STATE OF HAWAII DEPARTMENT OF TRANSPORTATION HIGHWAYS DIVISION	
INDEX TO DRAWINGS	
RAMP-IF	
STA: 78+17.13 TO STA: 85+37.69	
AIRPORT INTERCHANGE	
F.A.I. PROJECT No. I-HI-1 (174)16	
SCALE: N.T.S.	DATE: SEPT. 1982
SHEET No. I-1 OF 42 SHEETS

Contract Change Order No. 2 - Footing 30F Revision

STATE OF HAWAII DEPARTMENT OF TRANSPORTATION HIGHWAYS DIVISION	
REVISED FOOTING 30F DETAIL	
RAMP IF	
AIRPORT INTERCHANGE E.A.I. PROJ. NO. I-HI-1 (174) 16	
SCALE: AS SHOWN	DATE: JULY, 1983
SHEET NO. 8A OF SHEETS

LIMITS OF STRUCTURAL EXCAVATION PAYLINE PIER NO. 31F
Not to scale

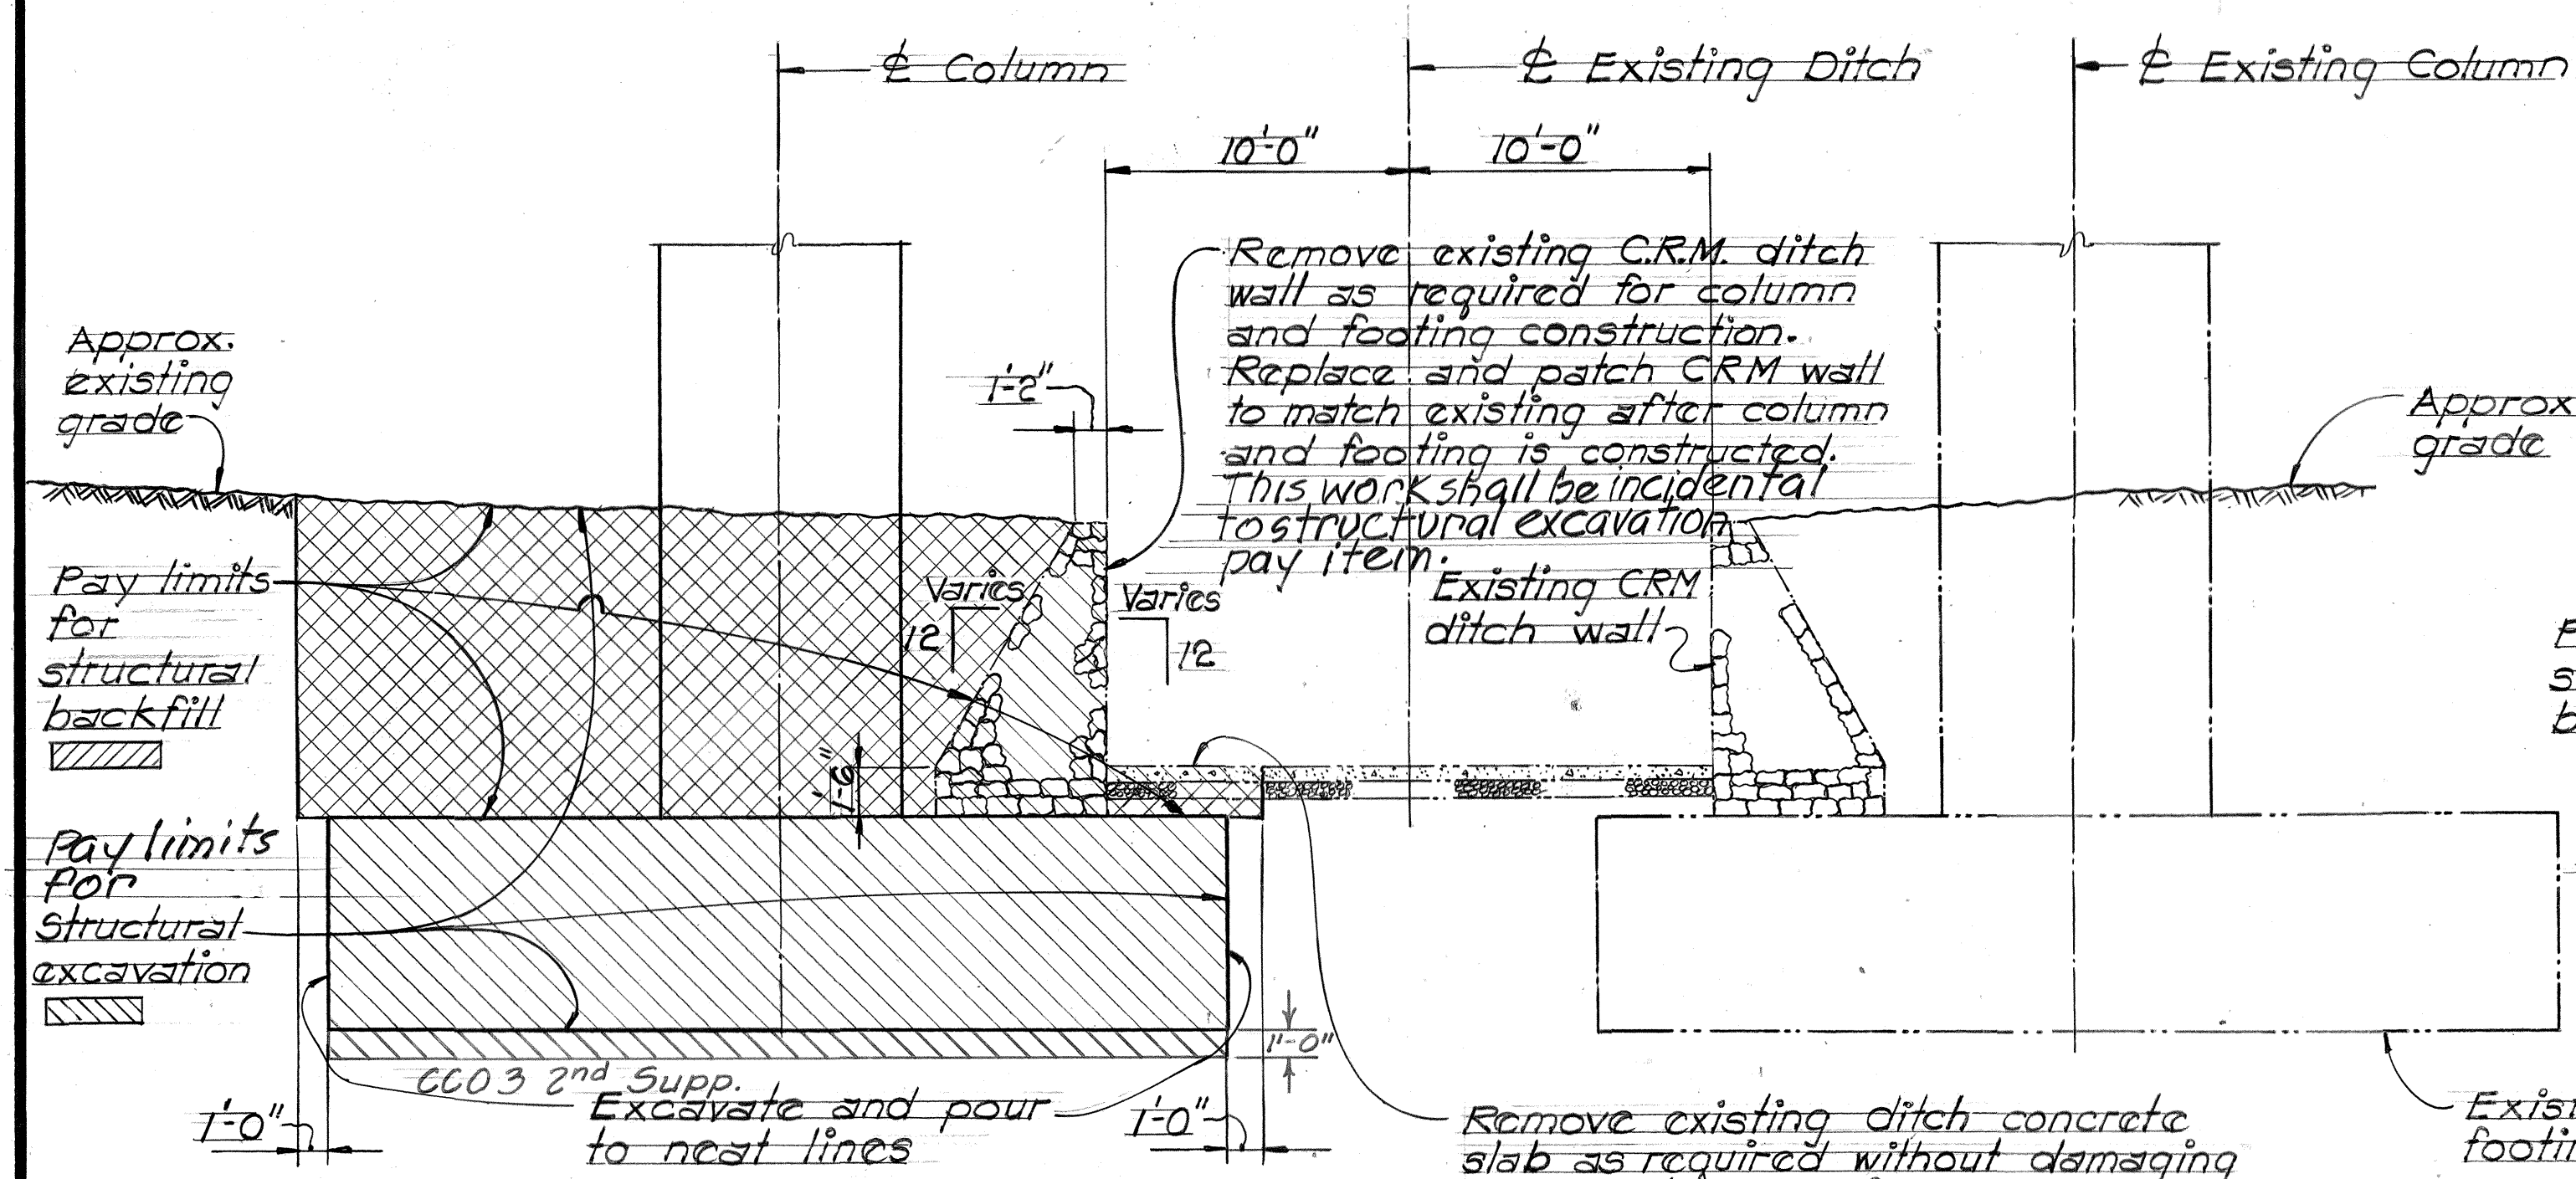
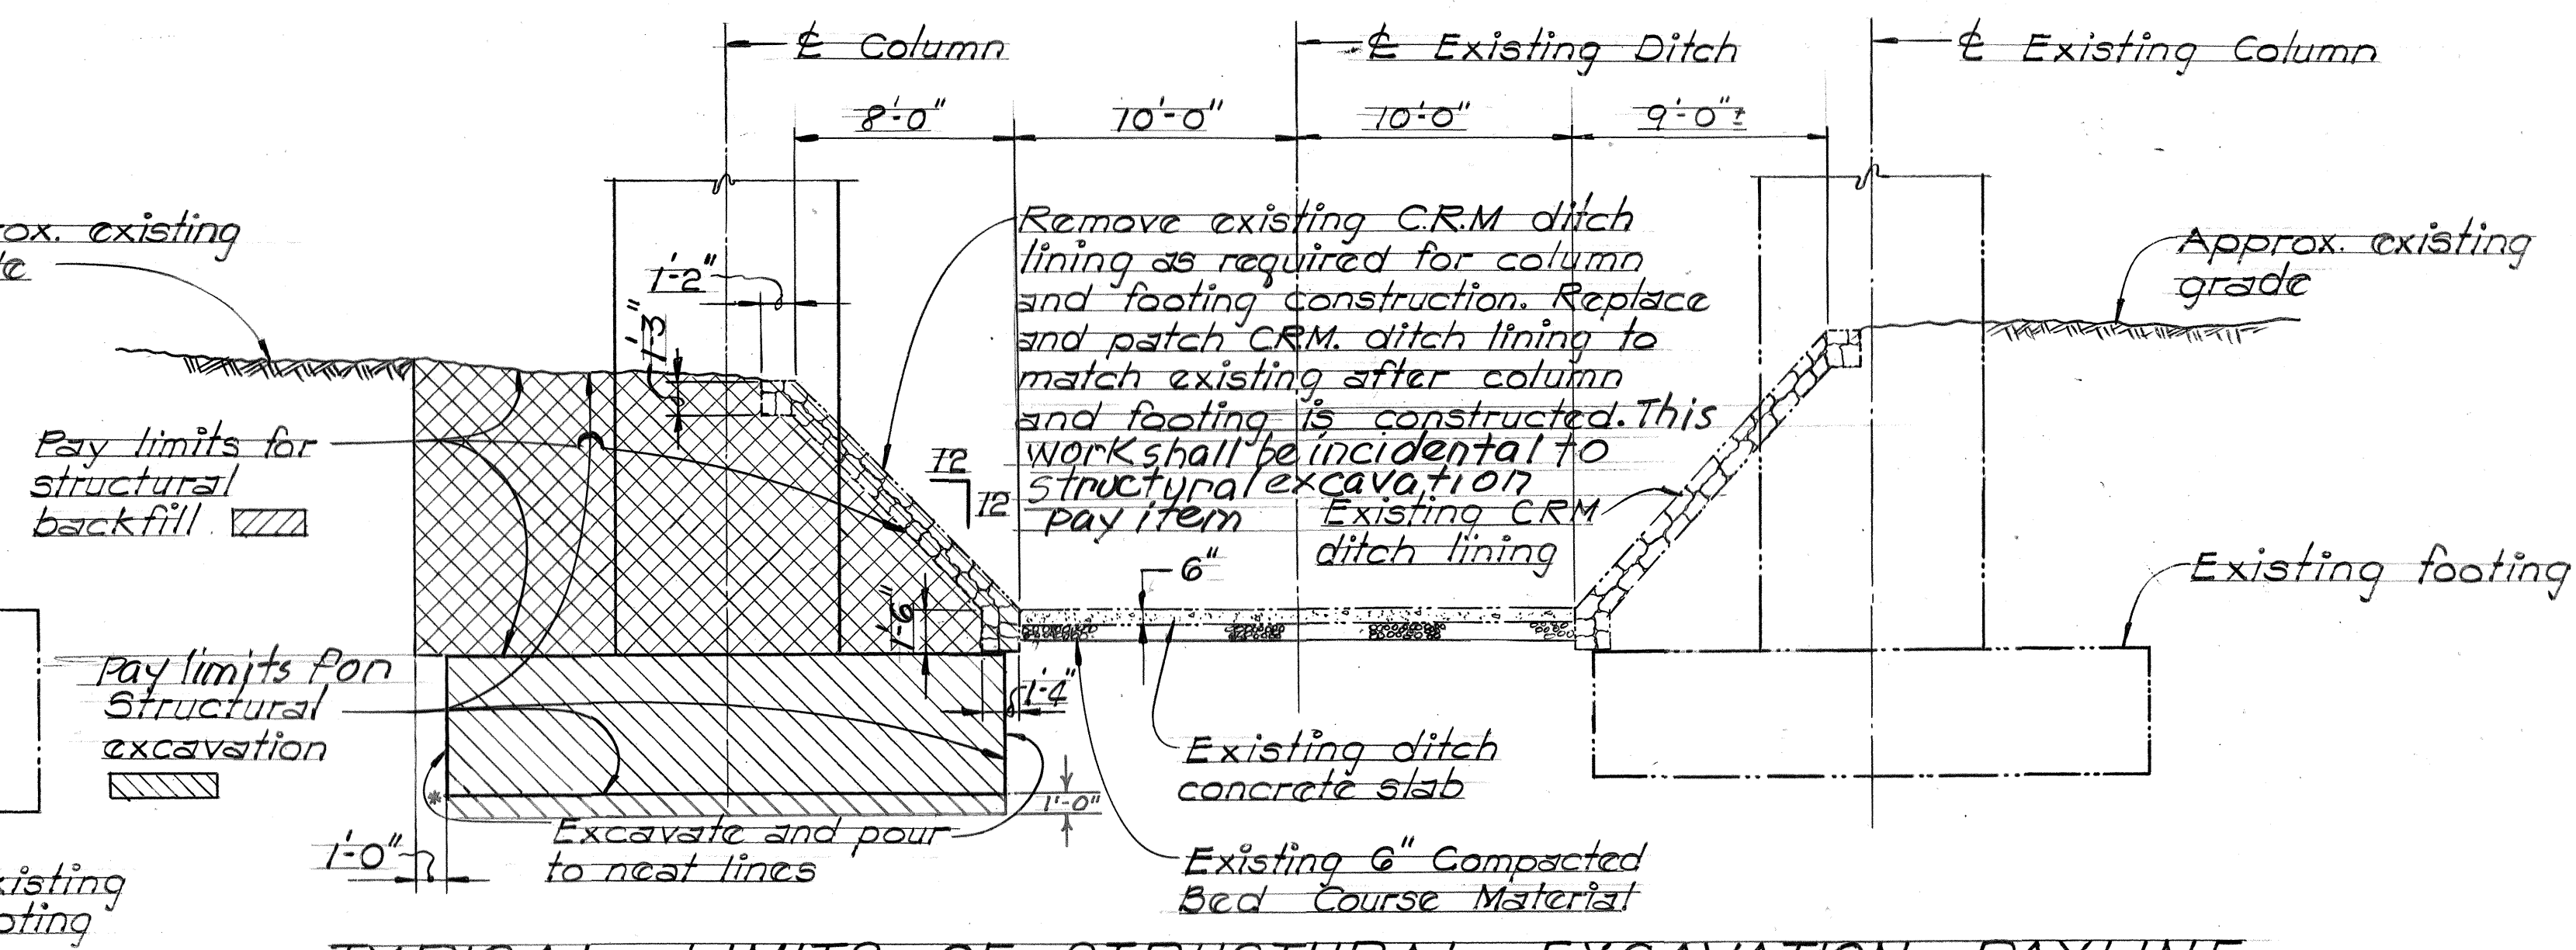
*CCO 3 For No. 32
CCO 3 1st Supp. For No. 33
